HISTORIC DISTRICT COMMISSION

1. Habitat for Humanity New Residence

OLD CONWAY DESIGN OVERLAY CERTIFICATE OF APPROPRIATENESS REVIEW

Address. 716 Pine Street

Proposed Front Façade with Suggested Modifications

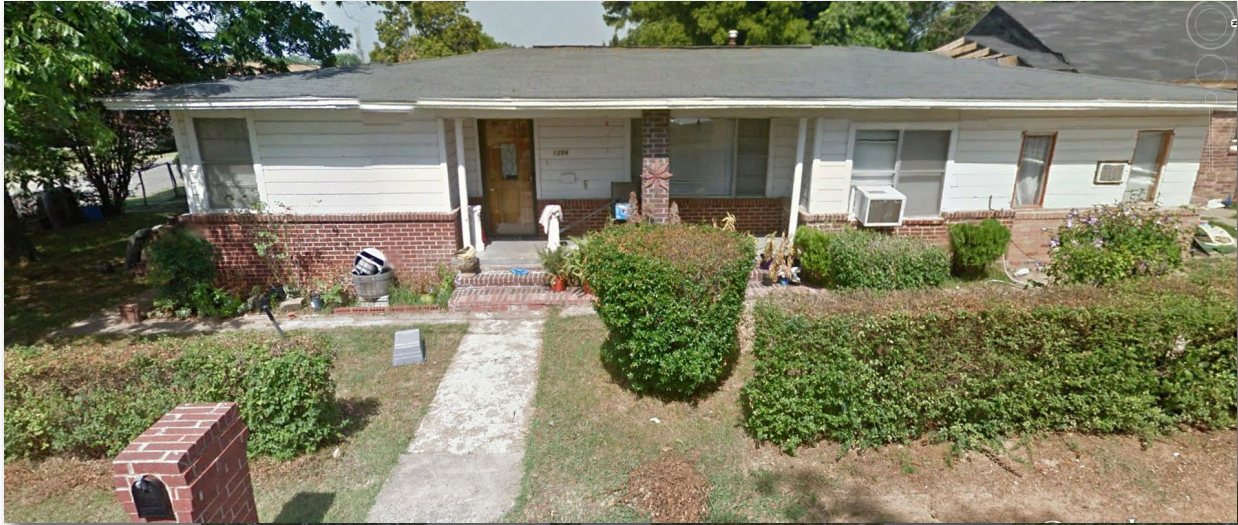
Façade, wall area, rhythm. Facades shall be compatible with surrounding historic structures in proportion of wall to opening area. The home has a correct ratio of windows and doors providing an appropriate level of wall to void rhythm. However, one additional window should be provided in the northeast bedroom as noted on the floor plan.

8. One additional window is required on the east wall as shown on plans.
9. Craftsman style, wide trim shall be used around windows and doors. Tapered columns shall be scaled accordingly; approximately 12" wide at base. Vinyl siding may be used.
